RE: Negative Declaration Regarding the Need for an Environmental Impact Statement for the TH 169/TH 41/CSAH 78/CSAH 14 Intersection Improvement Project, Scott County, MN (S.P. 070-596-013/ 7005-121/7009-81/7010-109)

FINDINGS OF FACT and CONCLUSIONS

TH 169 at TH 41/CSAH 78 and TH 169 at CSAH 14 Intersection Improvements

**State Project No. 070-596-013, 7005-121,
7009-81, 7010-109**

Figure 13c: Proposed Floodplain Impacts and Crossings
 US 169/TH 41/CSAH 78/CSAH 14 Intersection Improvements
 SP 070-596-013/7005-121/7009-81/7010-109
 Scott County, MN
 June 2017

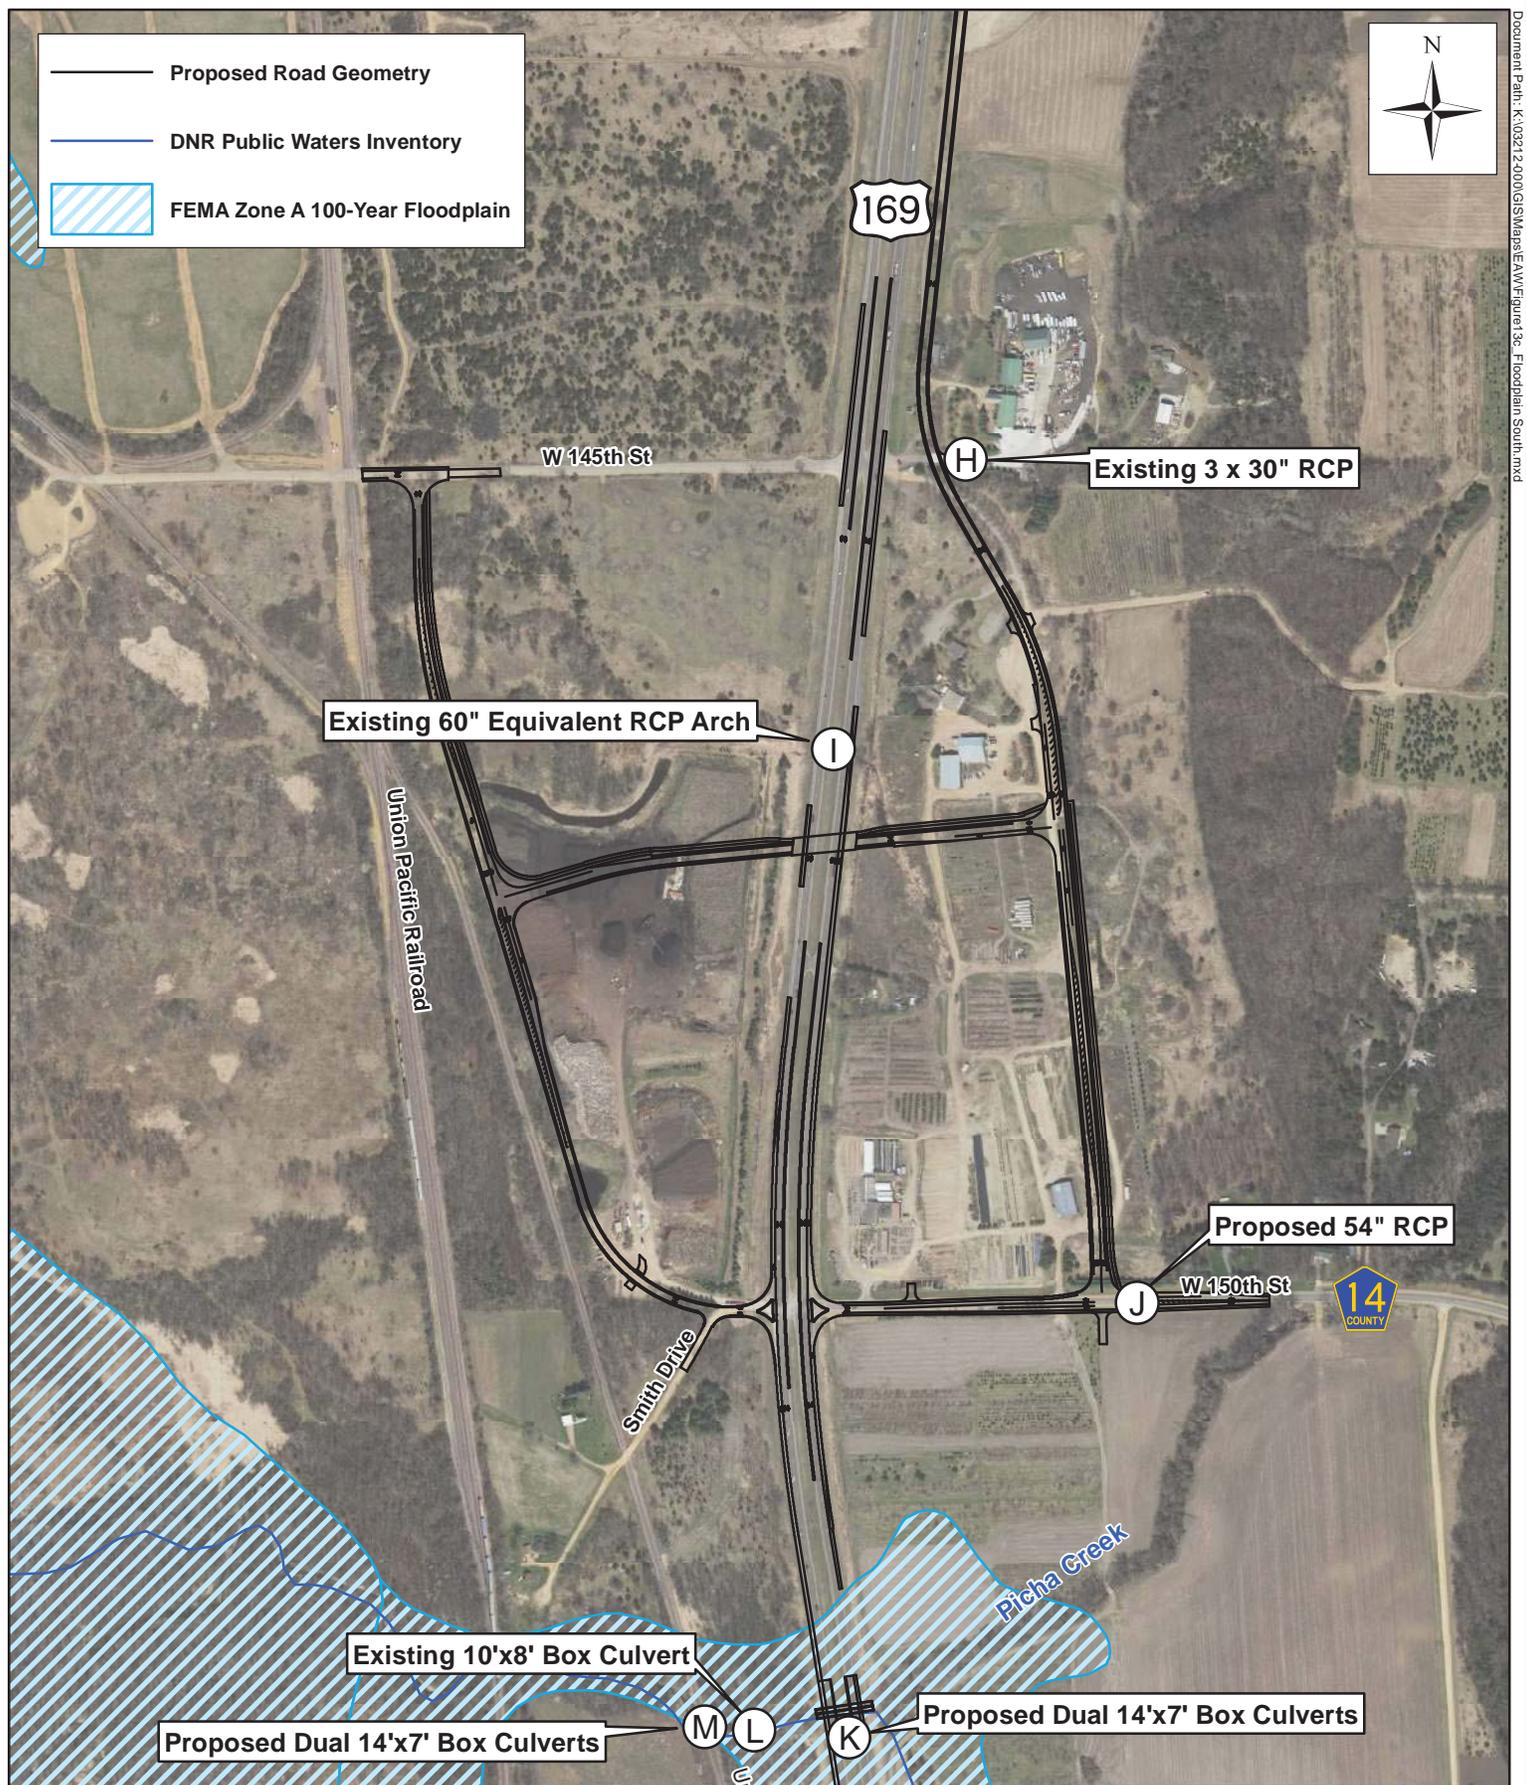
- 3.2.4 Information related to floodplain impacts has been updated and identified in Figure 13c in **Appendix C**. Also see **Appendix F** for updated floodplain assessment and hydraulic risk analysis documentation (Attachment F of the published EAW).

The 10-foot by 8-foot box culvert under Old 169 (now a field road) at Picha Creek (Crossing "L") was previously identified for removal as part of the project. Based on concerns regarding right of way and maintenance access at this location, this culvert is no longer proposed for removal. Analysis has indicated that this culvert is not causing the periodic overtopping of TH 169, nor is it causing the periodic flooding upstream of TH 169 at Picha Creek. Therefore, it is not necessary to replace or remove this culvert as part of the project.

Floodplain: As described under Section 3.2.4, information related to floodplain impacts has been updated since the time that the EAW was published. A box culvert under Old 169 at Picha Creek would no longer be removed as part of the project; therefore, the floodplain analysis no longer considers this activity as one of the activities occurring within a floodplain area. See the updated Figure 13c in **Appendix C** and the updated floodplain assessment and hydraulic risk analysis in **Appendix F**.
